NUCLEAR REGULATORY COMMISSION

URFO:ROG
Docket No. 40-8084
SUA-1119, Amendment No. 24
04008084160R

SUBJECT: AMENDMENT NO. 24 TO SOURCE MATERIAL LICENSE SUA-1119
FOR THE RIO ALGOM MINING CORP., LISBON MILL

405 ACRES TOTAL
CONTRIBUTING TO
LOWER POND

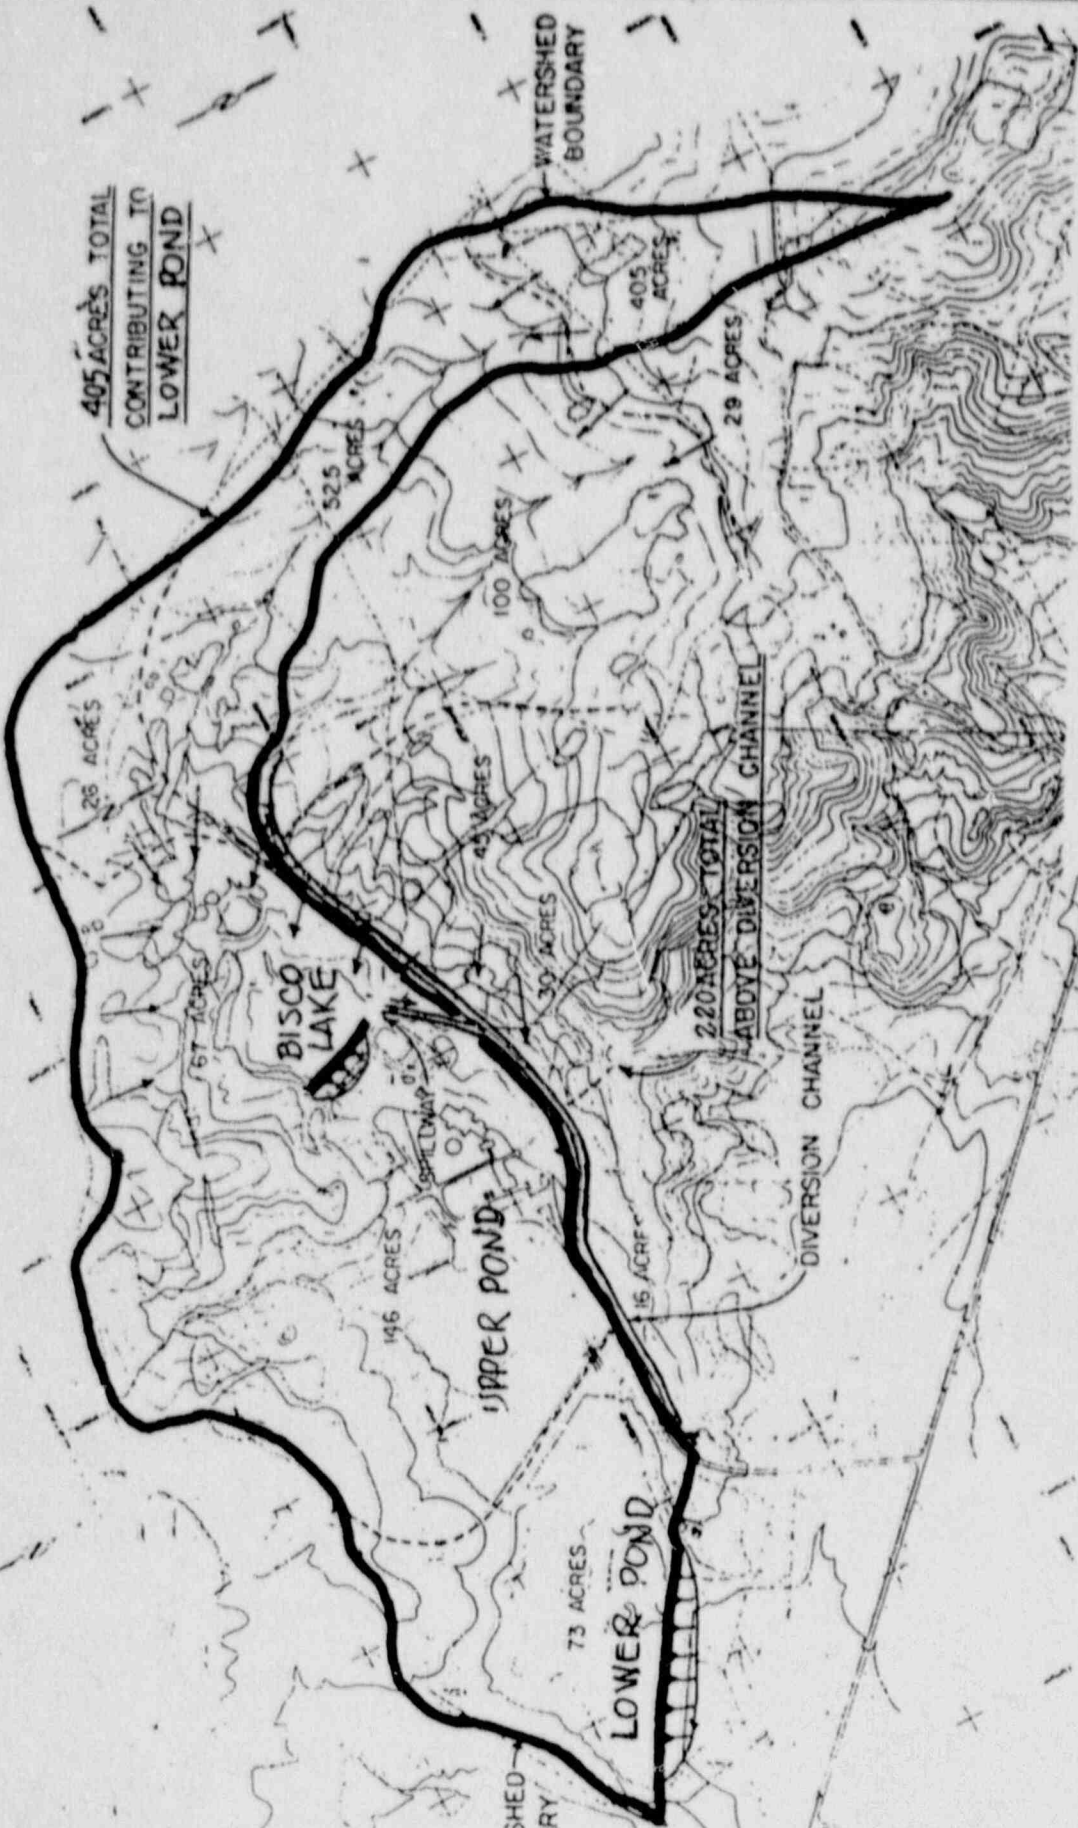
In determining the current 11-foot freeboard required for the Lower Pond, the staff conservatively assumed that during a PMF, Bisco Dam would fail and its entire contents would drain into the Lower Pond. The 11 feet of freeboard therefore provides sufficient storage to contain the entire PMF runoff from a 405-acre upstream drainage area plus the entire content of Bisco Lake. The 405-acre area includes 186 acres upstream of Bisco Lake, plus 219 acres downstream of Bisco Lake (see Figure 1). The analysis performed in estimating the 11-foot freeboard requirement is conservative in that the entire volume in Bisco Lake was assumed to flow into the Lower Pond during a PMF. In reality, this would not occur because part of the PMF inflow to Bisco Lake would be diverted away from the Lower Pond.

Bisco Dam has a spillway at an elevation of 6727 feet. This is 17 feet below the elevation of the crest of the dam, which is at 6734 feet. During a PMF, water will flow through the spillway and into a diversion channel. Water that flows into the channel will be diverted away from the Lower Pond. In order to determine the volume of flood water that could flow into the Lower Pond, the staff independently calculated a PMF hydrograph for the 186-acre area upstream of Bisco Lake. This PMF was then routed into Bisco Lake and through the spillway. This analysis indicated that the maximum water level in Bisco Lake during a PMF would be 6728 feet. The storage at this elevation is 95 acre-feet. Assuming that Bisco Dam would fail when the lake was at its maximum level, would result in the release of 95 acre-feet of water, which would drain into the Lower Pond. Adding to this, the PMF volume from the 219-acre area downstream of Bisco Dam results in a total runoff volume of 223 acre-feet. The Lower Pond must therefore have sufficient freeboard to provide storage for this volume of runoff in addition to an allowance for windwave runup. The staff performed an analysis to determine the windwave runup during a PMF and concluded that a total freeboard of at least 6.8 feet is required for the Lower Pond. On the basis of this analysis, the staff concluded that a minimum freeboard of 8.5 feet proposed by RAMC is acceptable.

The staff thus concludes that a minimum freeboard of 8.5 feet during the period of May 1 through October 31 and at least 5 feet during the period of November 1 through April 30, as proposed by the licensee, is adequate for the lower impoundment. License Condition No. 45(B) should therefore be amended as discussed below.
